New Barnsbury, The Barnsbury Estate

Design & Access Statement - Addendum
Block D1 and D2 Top Floor Amendments

February 2023

3.8 Detailed Element Proposed UGF: Previous Design

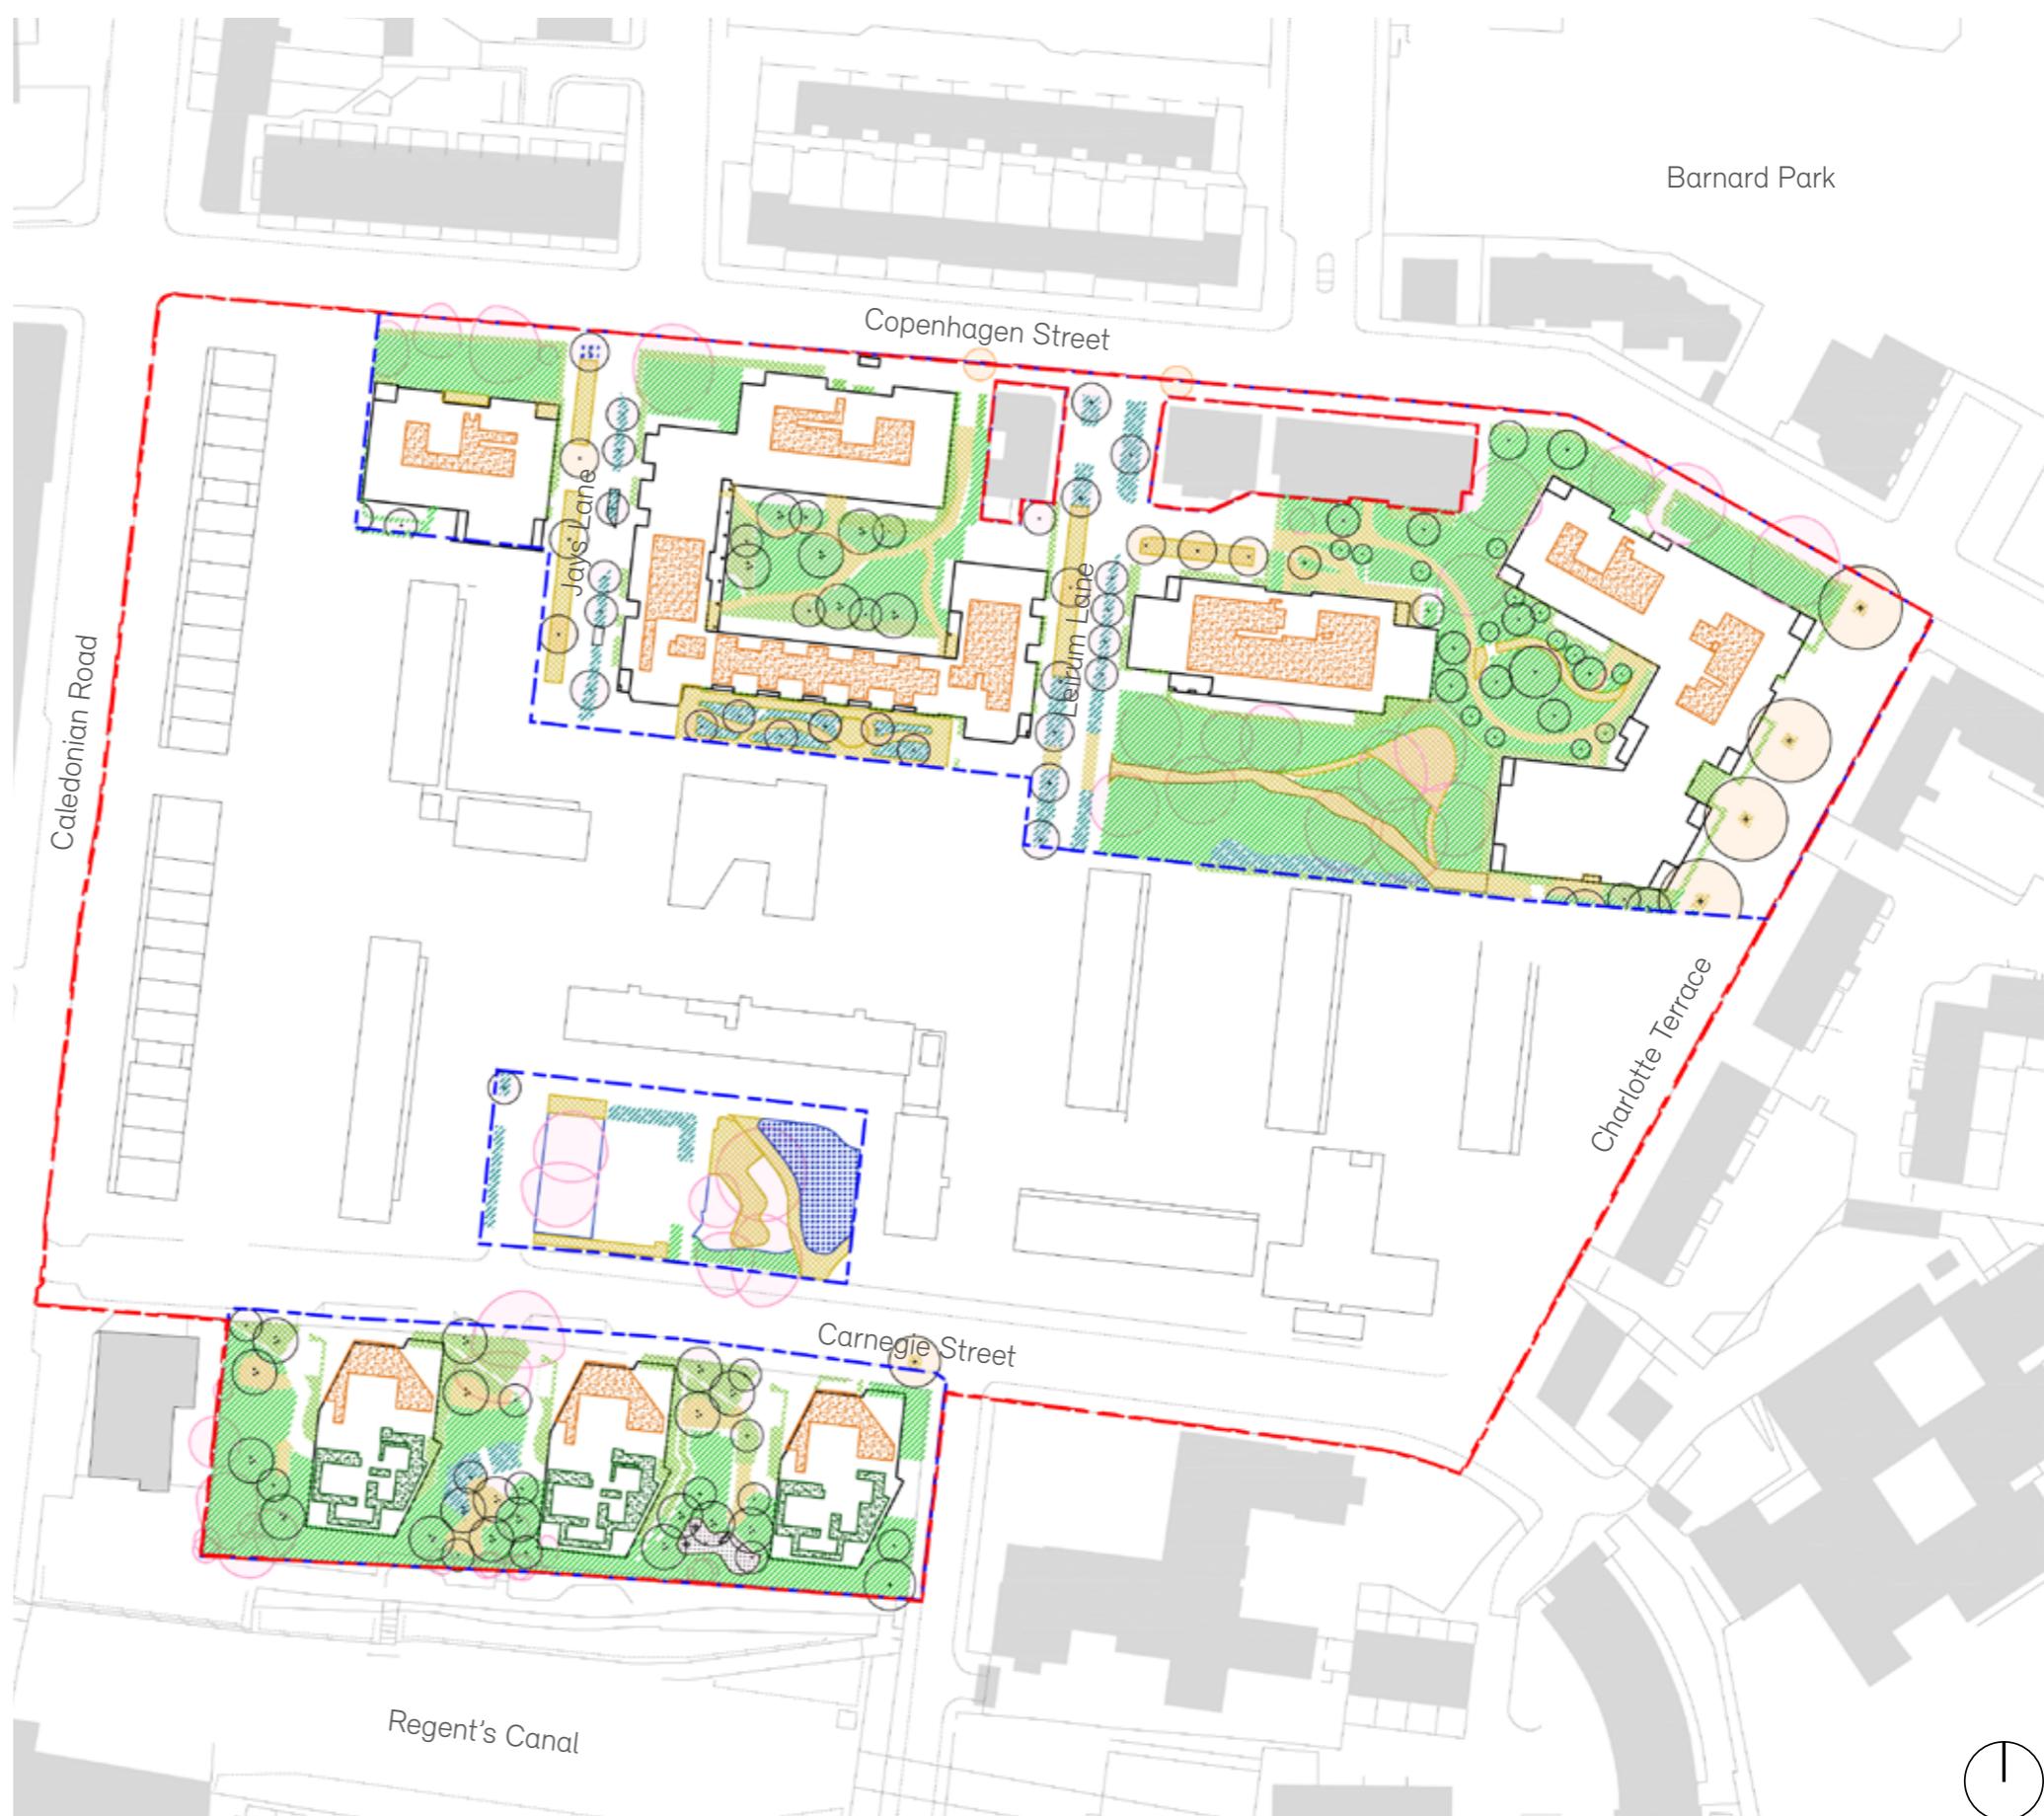
The proposed UGF within the Detailed Element is 0.52.

3.9 Detailed Element: Proposed UGF: Amended Design

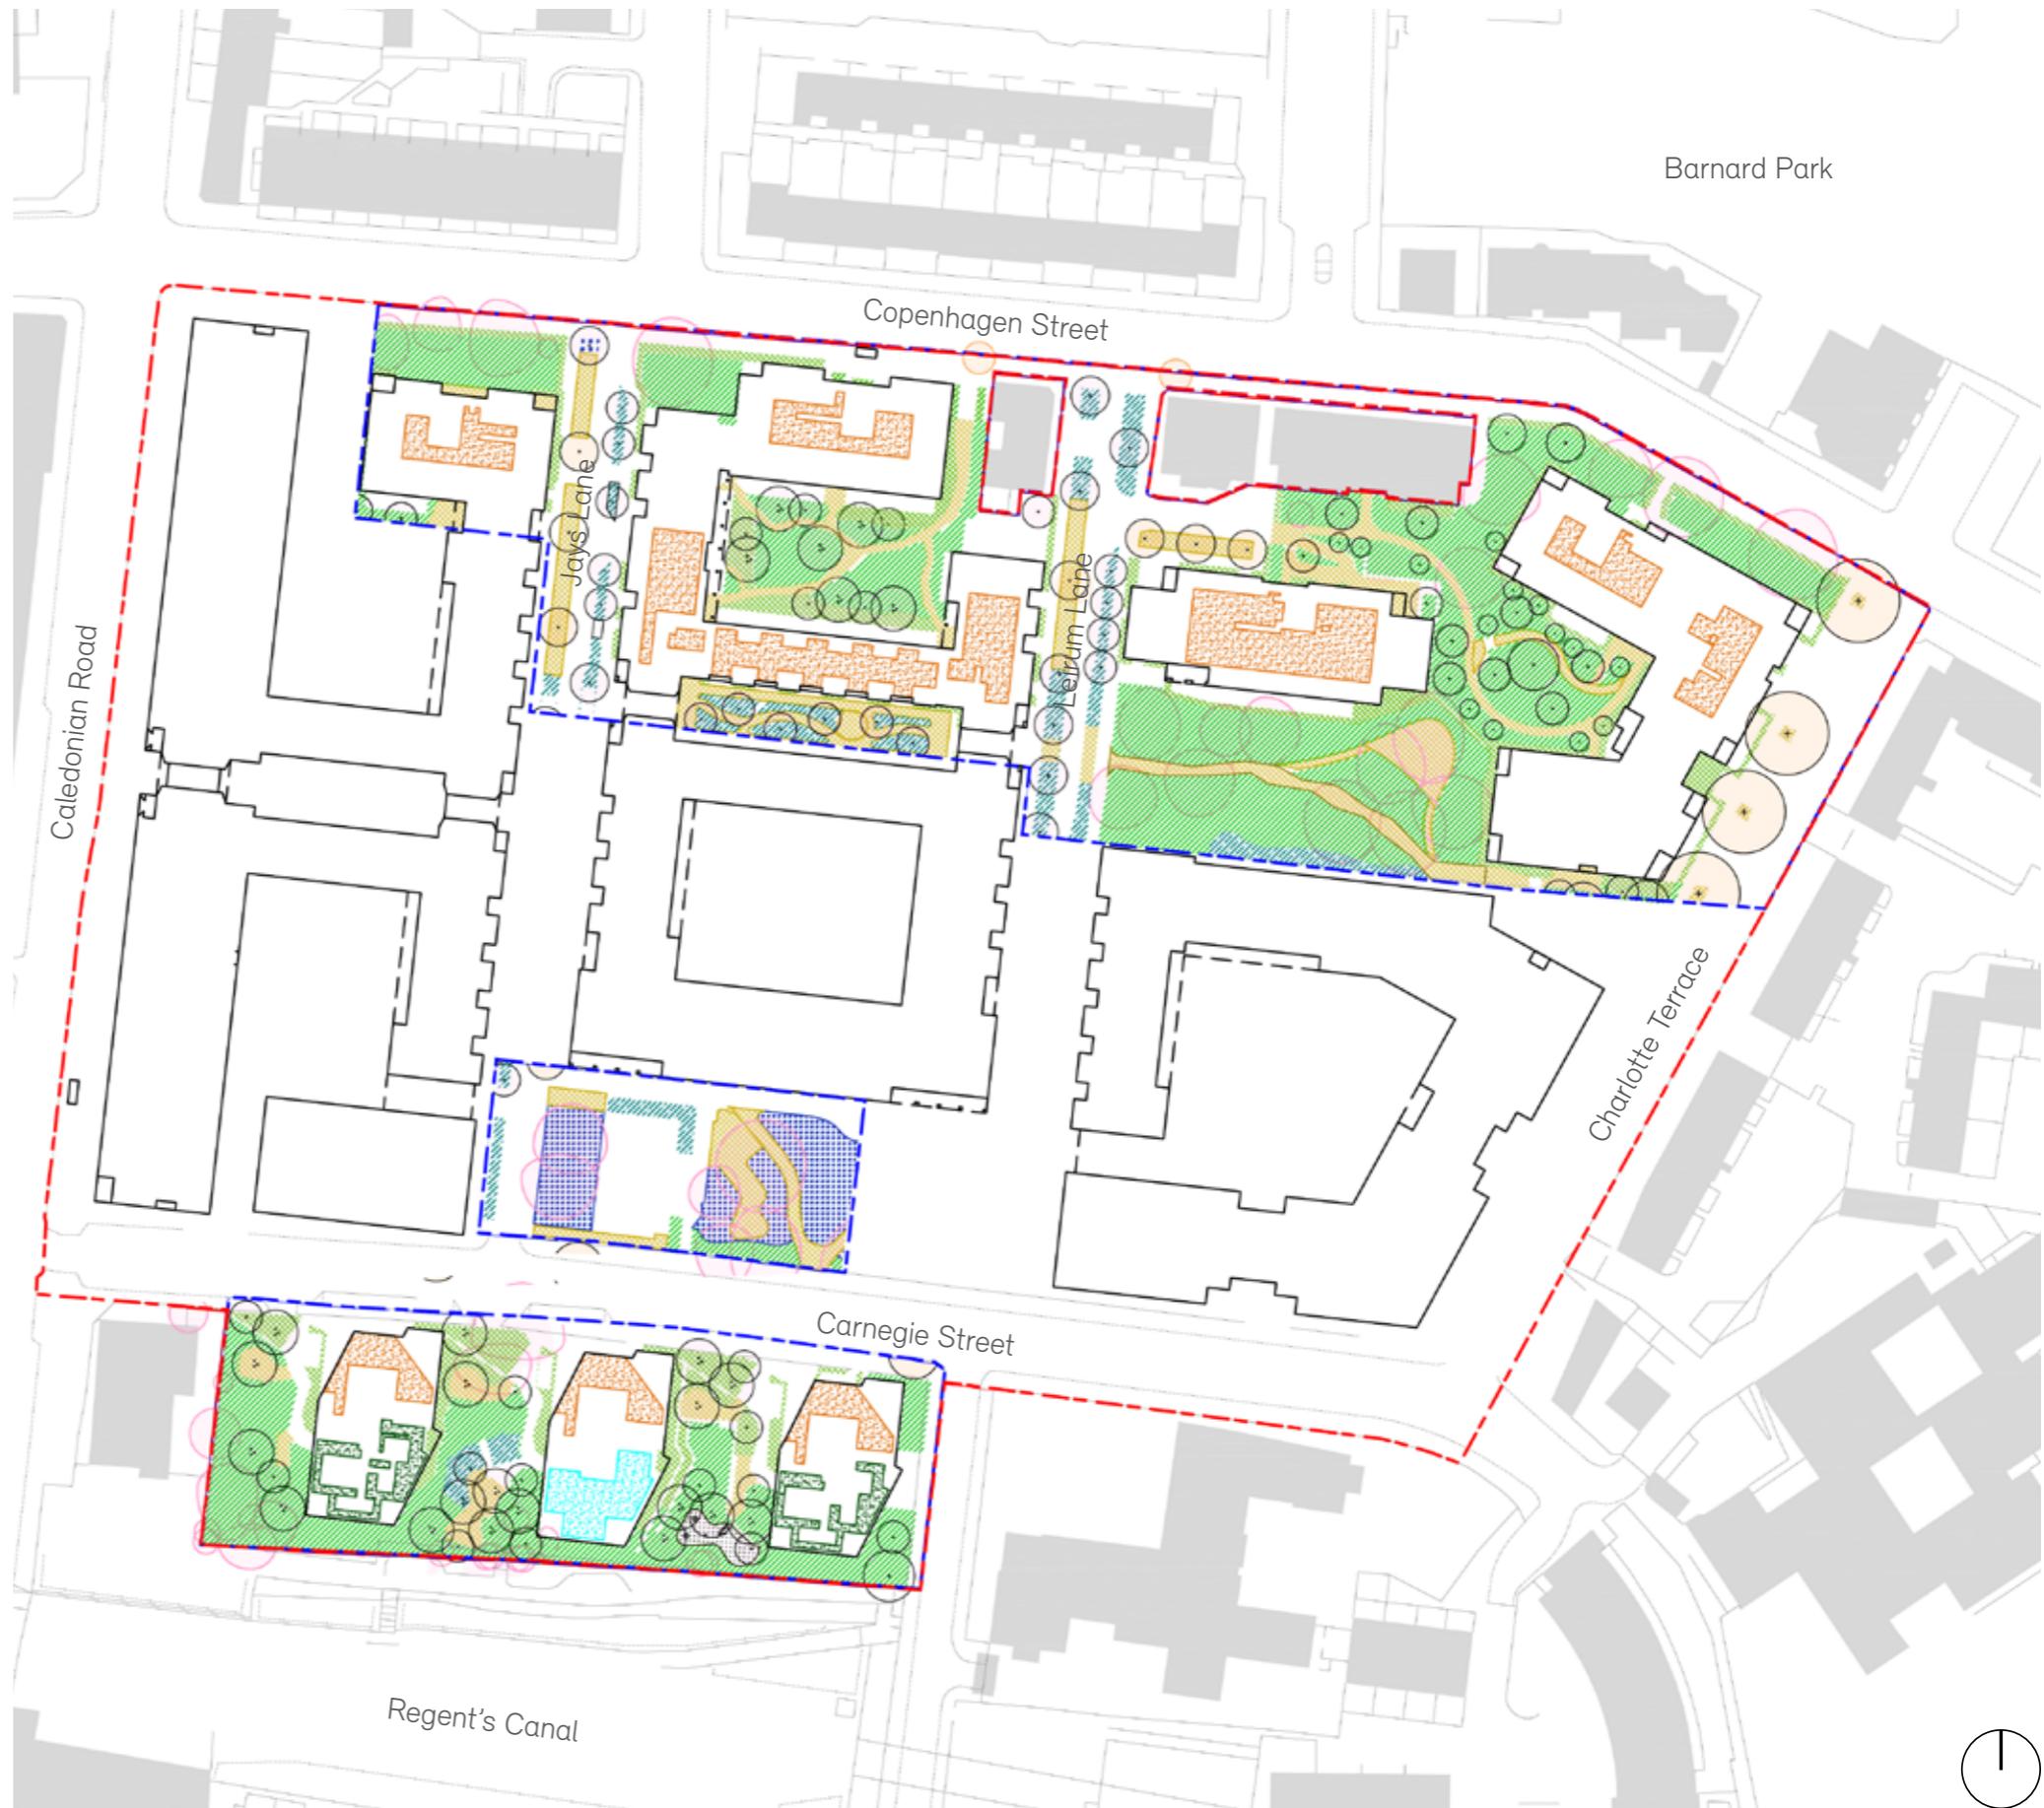
The proposed UGF within the Detailed Element is 0.52.

The only amendment to the UGF is that the Intensive Green roof on block D2 has been replaced with an Extensive green roof. The score of 0.45 is consistent with the previous design.

3.10 Canal Block Masterplan

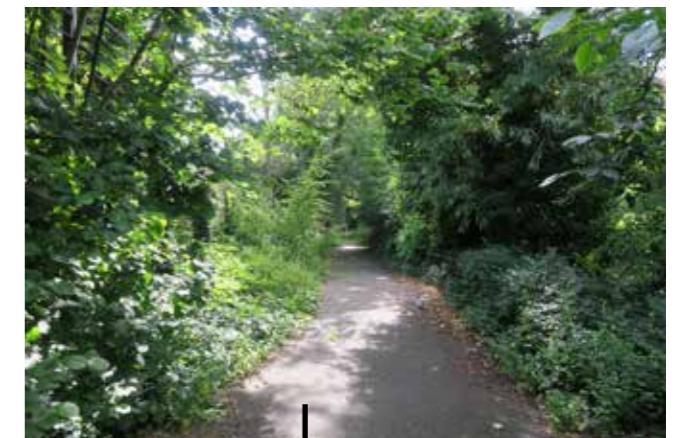
Changes to the landscape scheme have been isolated to the top of block D2, minimising impact to the consented design.

The amendments to Block D2 focus only on the rooftop.

The communal roof terrace has been removed from D2. This area of roof will be replaced with a bio-diverse Extensive green roof.
